BOARD ACTION REPORT – APPEALABLE ITEM

Project Name: The Grove
Project Location: 233-279 NE 2nd Avenue
Request: Class III Site Plan Modification
Board: Site Plan Review and Appearance Board
Meeting Date: February 22, 2017

---STAFF REPORT---

ITEM: **The Grove (2016-254):** Class III Site Plan Modification for **The Grove** (aka The Esplanade at The Grove) associated with modifications to the existing site plan, landscape plan and architectural elevations to accommodate a building expansion, use conversion, and external renovations to the existing facades.

EXISTING SITE PLAN

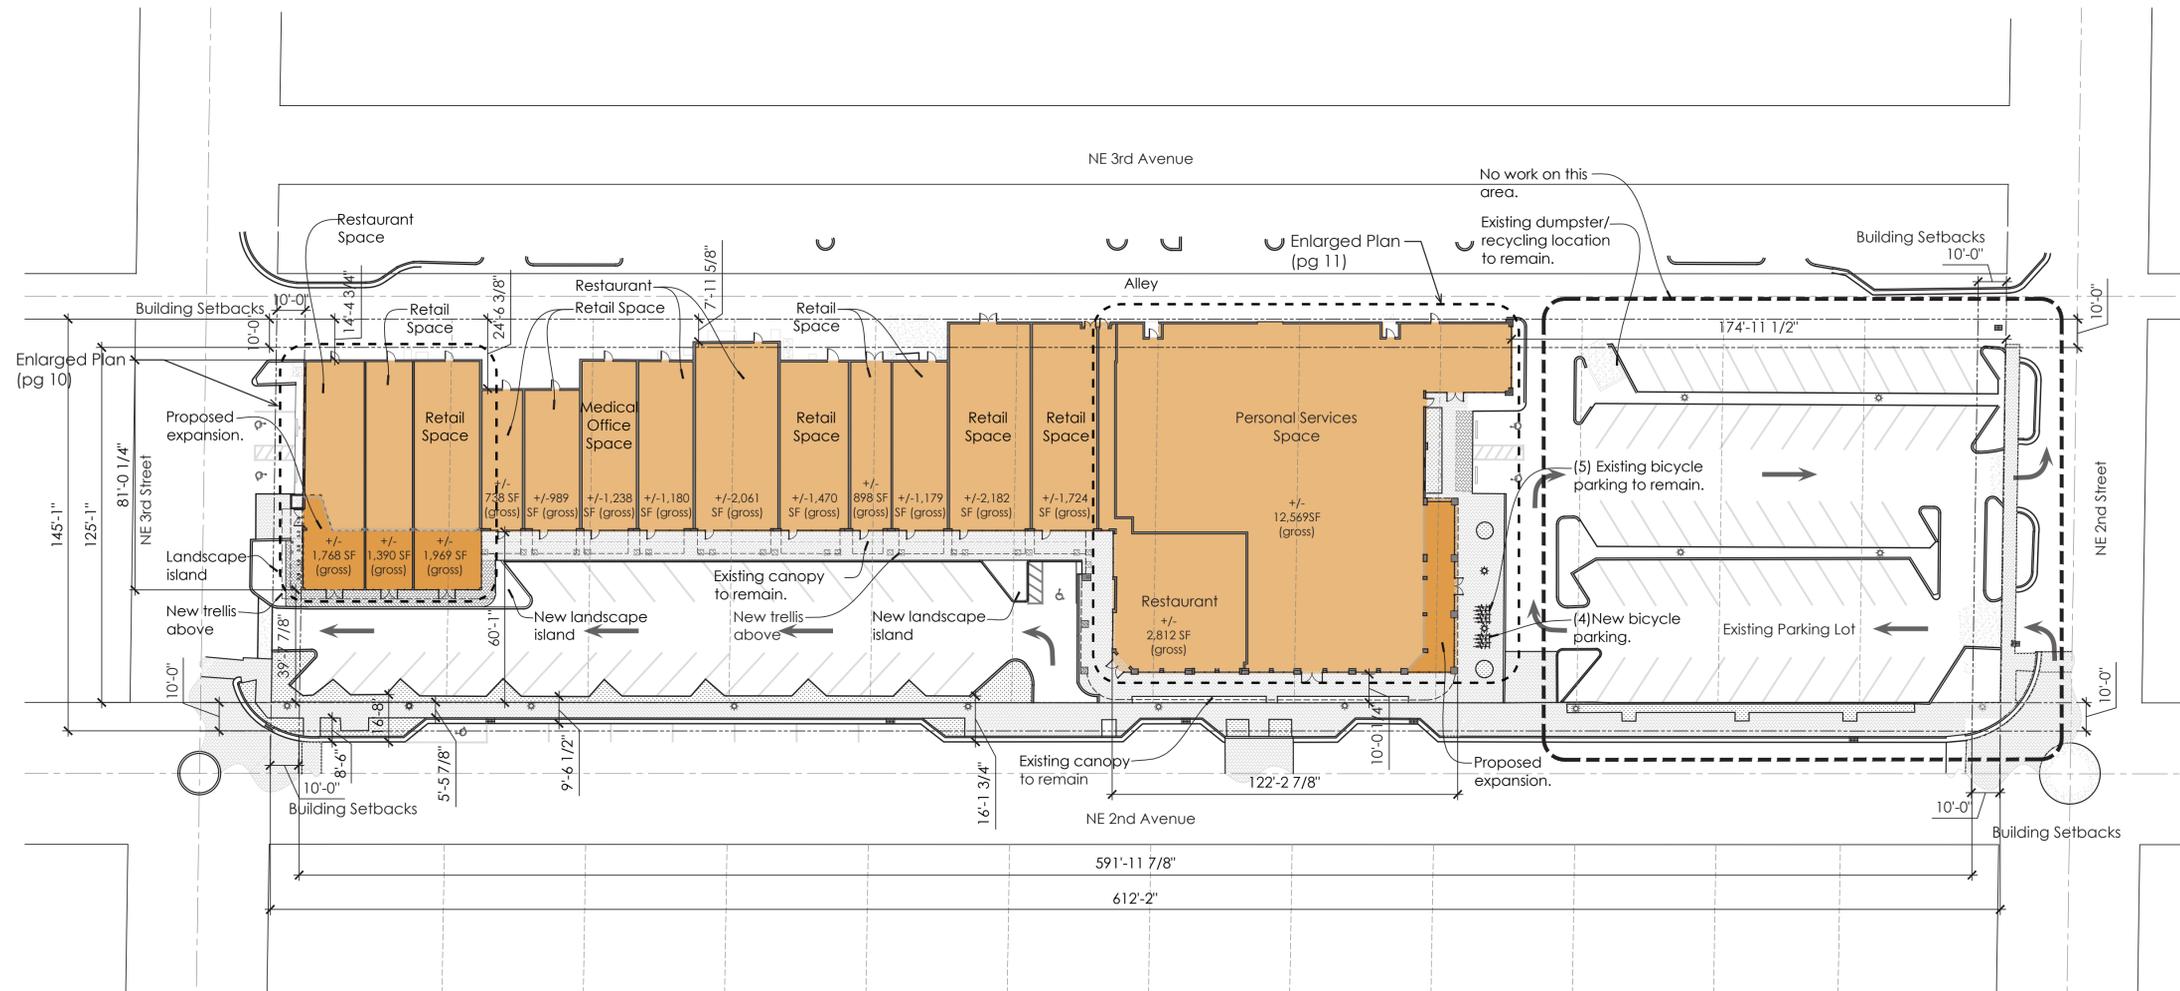
1. That a vision obscuring gate be installed on the fourth side to screen the existing dumpster;

Pursuant to LDR Section 4.6.6(C)(1), dumpsters, recycling containers and similar service areas must be enclosed on three sides with vision obscuring gates on the fourth side, unless such areas are not visible from any adjacent public right-of-way. The existing dumpster is located on the south parking lot area. The existing dumpster is enclosed on three sides and screened with landscaping on two sides. There is no gate on the fourth side, and it can be visible from the alley. Although, the existing condition is a legal non-conformity, it is recommended that a vision obscuring gate be installed on the fourth side to screen it.

Existing dumpster to remain. Recommendation of a vision obstructing gate be installed on the fourth side won't be acted upon.

PROPOSED SITE PLAN

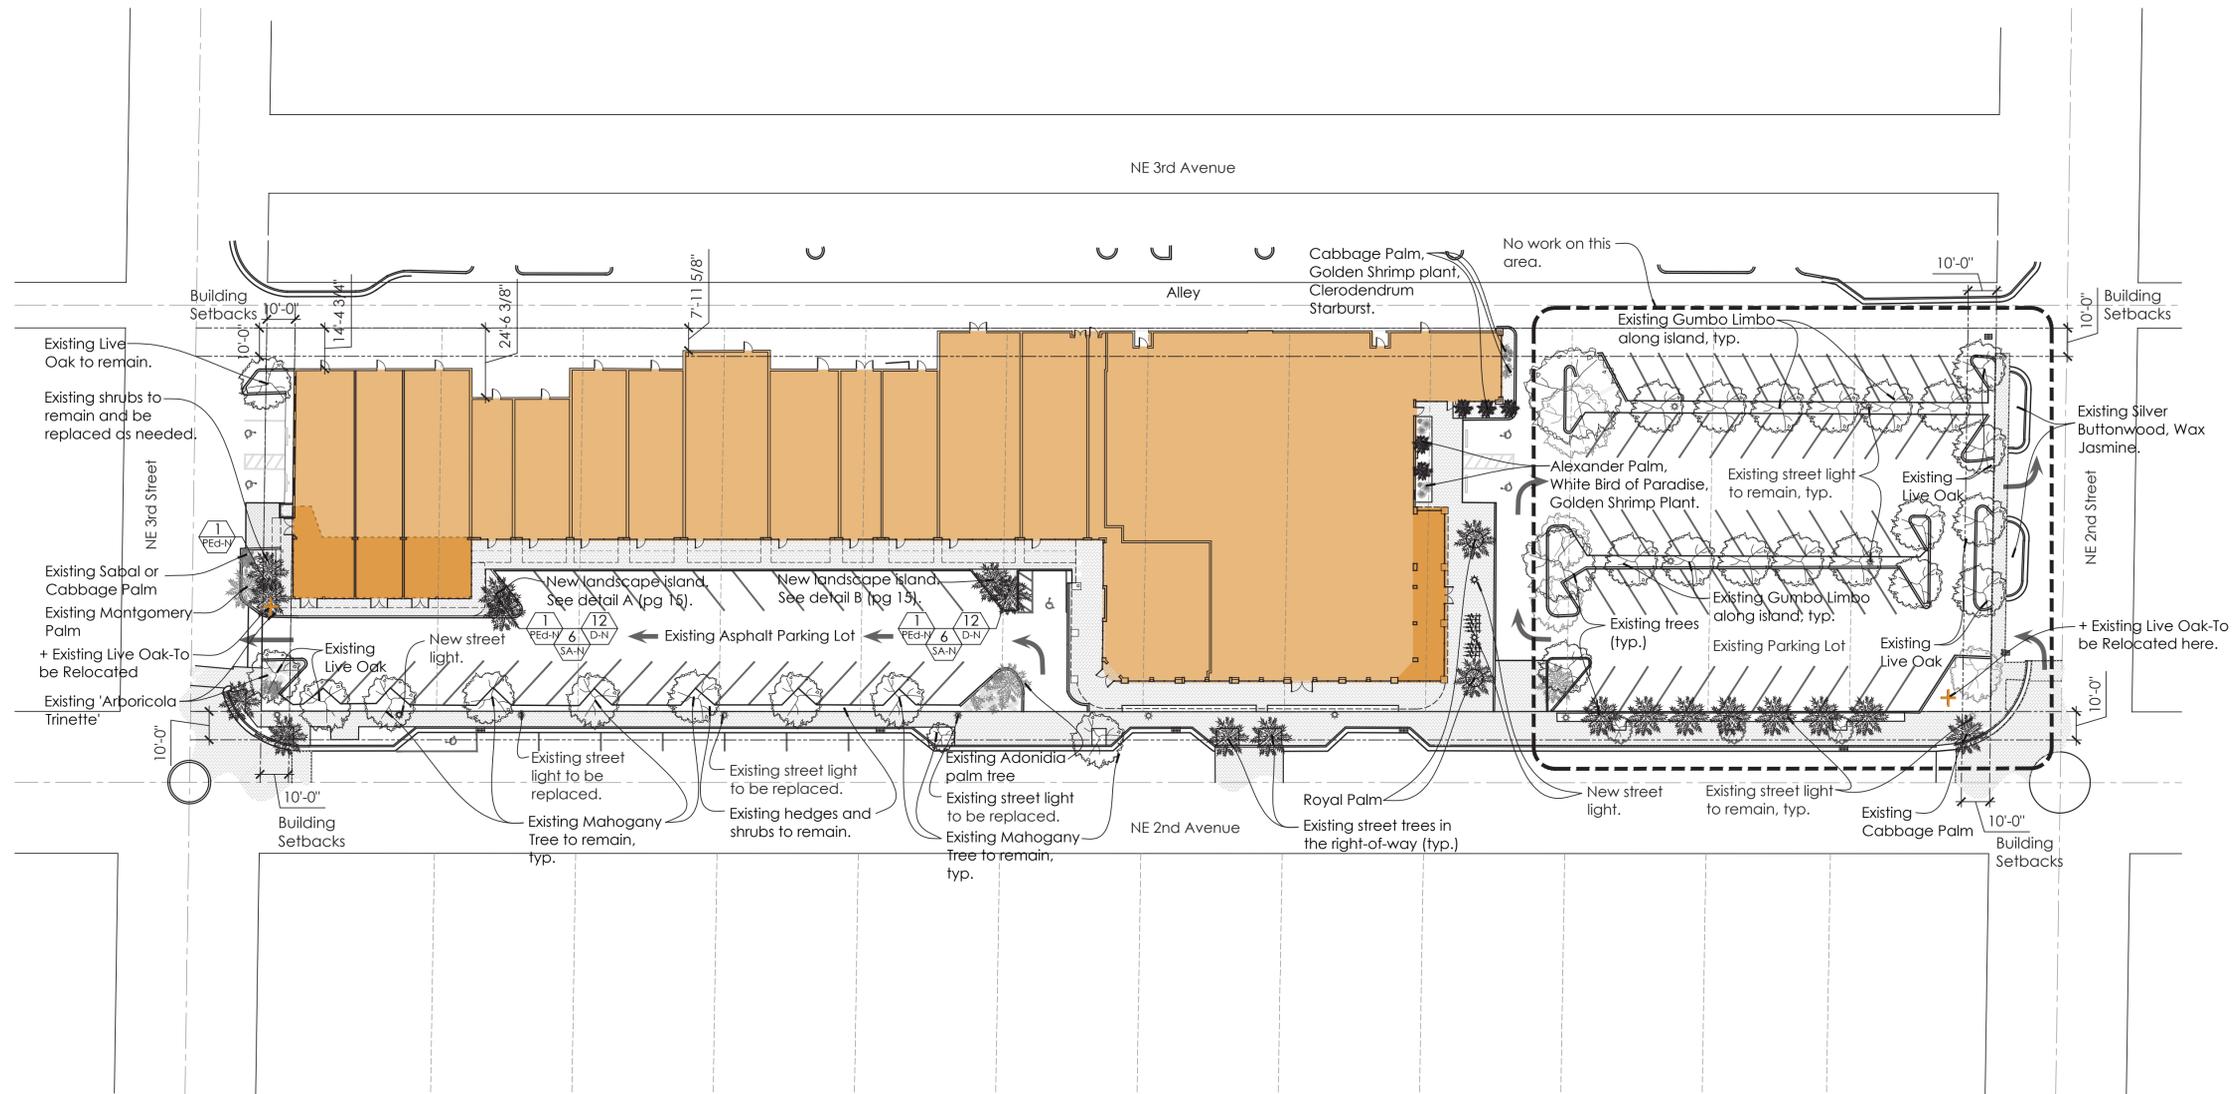
According to the shared parking calculation shown above, the minimum total number of required parking spaces is 93 spaces, and 97 off-street parking spaces are proposed. The proposed modification will provide a surplus of four parking spaces. Thus, the minimum total number of required parking spaces is met.

Per LDR section 4.4.13(l)(4)(3): bicycle parking requirements are applied to new development, expansion of an existing use, and changes of use. The site contains five bicycle spaces. The requirement for the minimum number of bicycle parking spaces for retail, restaurant and commercial uses is two spaces per 1,000 sq. ft. of gross floor area. The proposed expansion is required to provide four bicycle parking spaces ($1998/1,000 \times 2 = 3.99$ rounded to 4 parking spaces). The addition of four bicycle parking spaces is proposed which will total nine bicycle parking spaces on site; thus, this condition has been met.

LANDSCAPE ISLAND - DETAIL A
135 Sq. Ft.

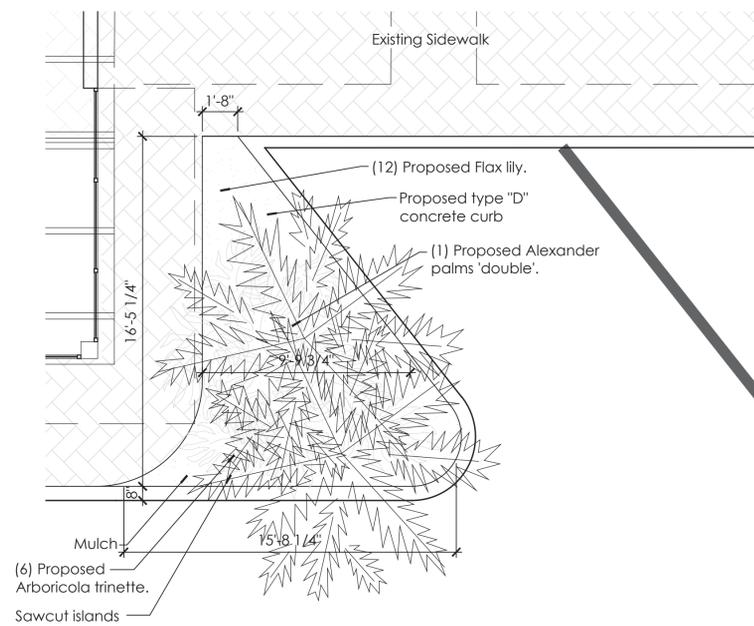
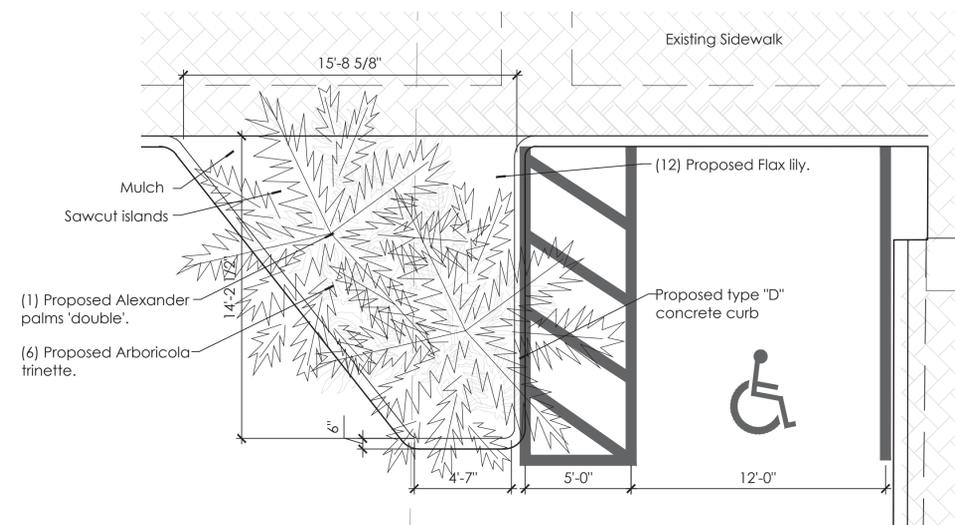
Pursuant to LDR Section 4.6.16(H)(3)(i), parking rows shall be placed at intervals of no less than one landscaped island for every 13 standard parking spaces. The east parking row proposed to be modified due to the building expansion has 12 spaces separated by a landscape island. Thus, this standard is met.

Pursuant to LDR Section 4.6.16(H)(3)(i), landscape islands must contain a minimum of 135 sq. ft. of planting area, with a minimum dimension of 9', exclusive of the required curb. Due to the configuration of the existing parking lot, it was not possible to accommodate 9' landscape islands; however, a minimum of 135 sq. ft. of planting area has been provided for the proposed planting areas between the east parking row located at the north corner. The addition of two planting areas between the existing parking row decreases an existing non-conformity; thus, this standard is met.
